SUBJECT: COMMENTS ON THE UMTRA PROJECT SURVEILLANCE AND
MAINTENANCE PLAN (PSMP)

As requested in TAR 85027, we have reviewed the geoscience aspects of DOE's UMTRA Project Surveillance and Maintenance Plan (PSMP: UMTRA-DOE/AL-350124). Although our preliminary review indicated that the quality of this document is significantly higher than site-specific UMTRAP assessments, we concluded that DOE's preparation and NRC's approval of such a plan is premature in light of existing uncertainties about the licensing process for UMTRAP sites. Based on our review, we question the purpose of the plan, which is stated on page 1 as to describe the procedures that will be used by NRC and DOE (or other responsible agency) to verify that stabilized UMTRAP sites comply with licensing requirements and the EPA standards (40 CFR Part 192, Subparts A, B and C) during the stabilization period. Our question of the plan's purpose is based on the following three concerns:

WMGT COMMENTS ON THE
UMTRA PROJECT SURVEILLANCE AND MAINTENANCE PLAN

ATTACHMENT
EXAMPLE BOREHOLE LOGS
(from DOE/EIS-0099-D)

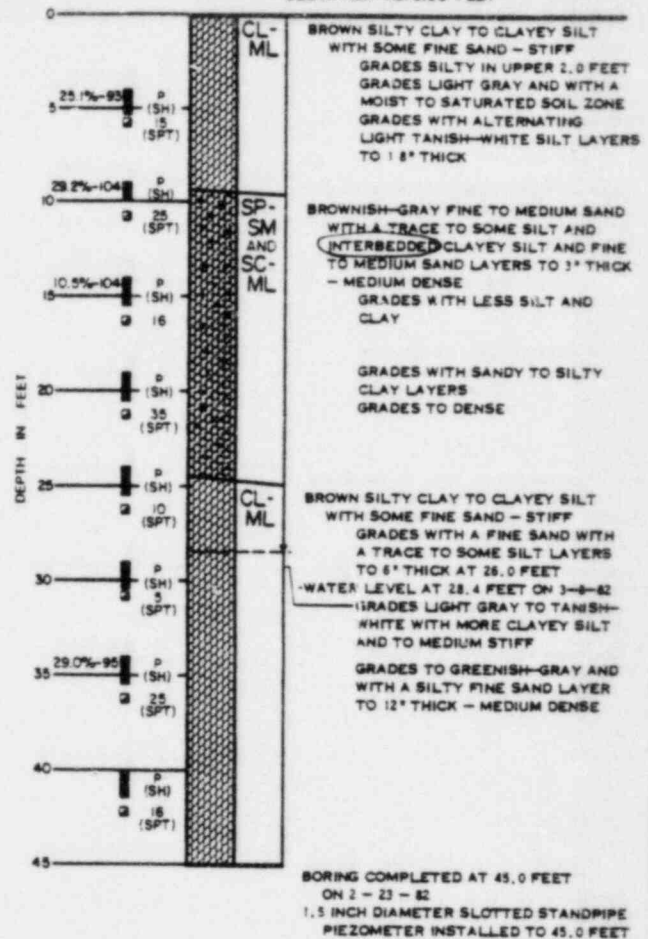
The borehole log form (Figure 2.8) appears to be an inefficient form for communicating and recording borehole logs. Standard borehole logs that provide a graphical representation of the units penetrated by boreholes are easier to read and in a glance can provide a rapid summary of the lithologies or sediment types encountered in borehole. Examples of such logs have been prepared at several UMTRAP sites, including the logs prepared by Dames and Moore at the South Salt Lake UMTRAP site or the logs by Bendix at the Durango UMTRAP site. If DOE decides to include examples of borehole log forms in the PSMP, the NRC staff recommends that Figure 2.8 be revised to increase the form's efficiency in recording and communicating information (see examples attached).
